PCN: V19-005-F48070-MA

Product Change Notice

Implementation of new Software version for AFBR-S50MV85G, new lens colour, new pin design and implementation of second assembly location

AFBR-S50MV85G
AFBR-S50MV85G-EK

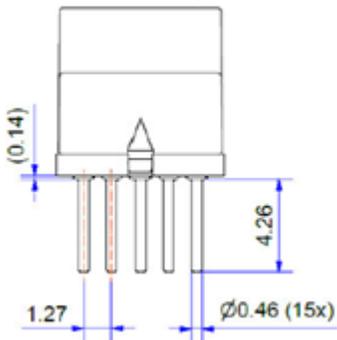
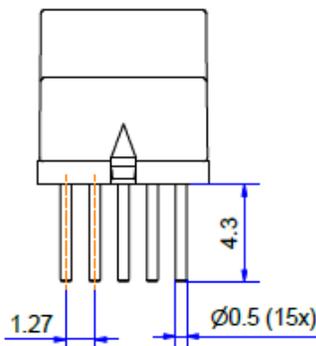
Current situation:

- Software version 0.9.5
- Lens colour black
- Pin diameter 0,46mm with 0,14mm flange
- Product assembly in Europe

Change:

- Software version 1.0
- Lens colour transparent
- Pin diameter 0.50mm without flange
- Product assembly in Europe and Asia
